Service Bulletin

No. : MZ07-017

Model: MA-9S2

Subject: Audible Pop noise

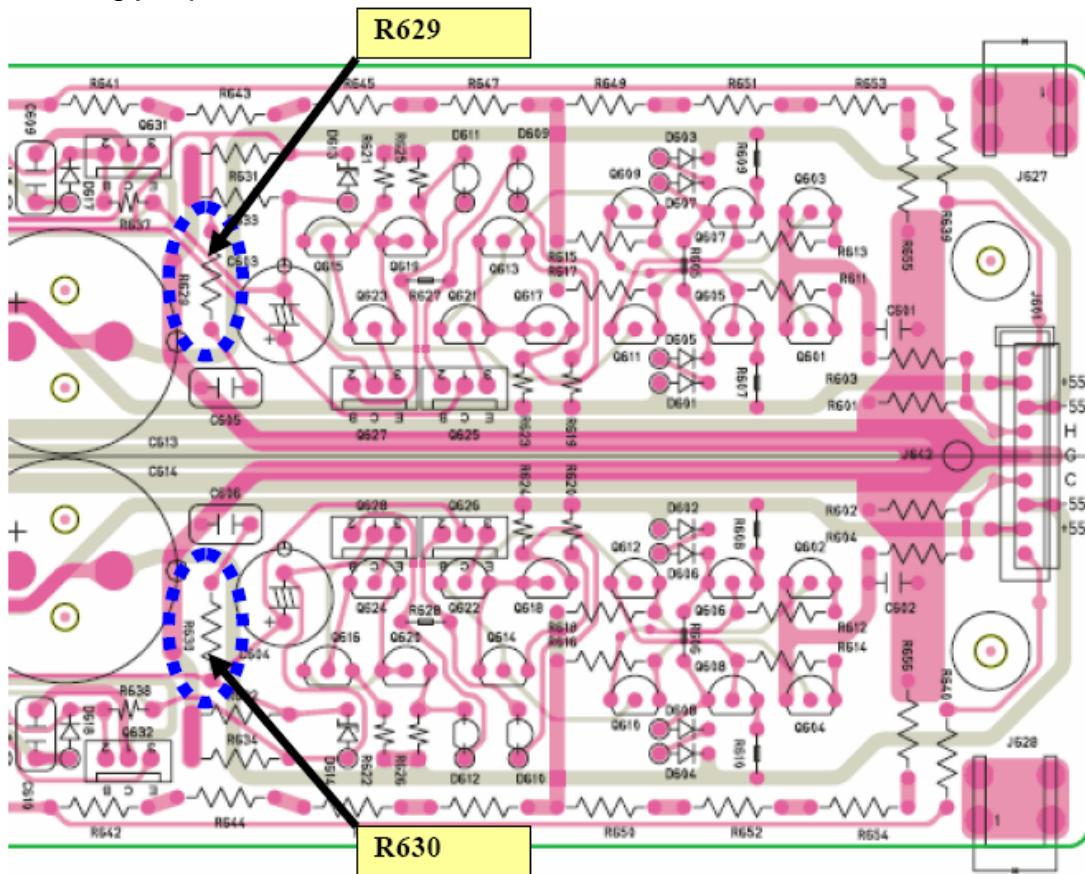
Symptom: The product can generate a pop noise when powered on/off. The problem tends to occur when the unit is switched on/off while connected to the SC-7S2 with a balanced cable.

Solution: 1. Replace the 10 ohm resistor with a jumper at each of the R629 and R630 sections on the MAIN PWB (P601).
2. Solder and bond a 220pF to the Land Pad of R521 and R522 on the rear of the INPUT AMP PWB (P501).

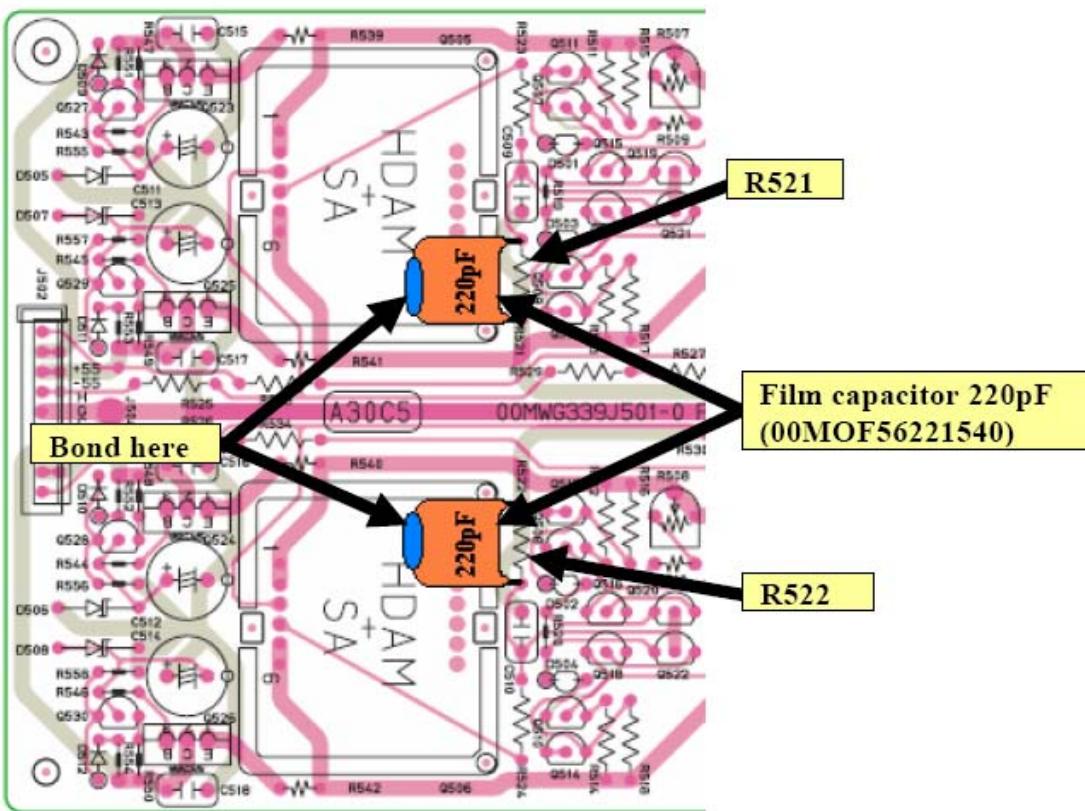
1. Replace the R629 and R630 (both 10 ohms) on the MAIN PWB (P601), with a 10mm-long jumper:

2. Solder and bond a 220pF (Part No: 00MOF56221540) to each of the R521 and R522 on the rear of the INPUT AMP PWB (P501). For bonding, please use SONY Chemical SC608LVZ or the equivalent.
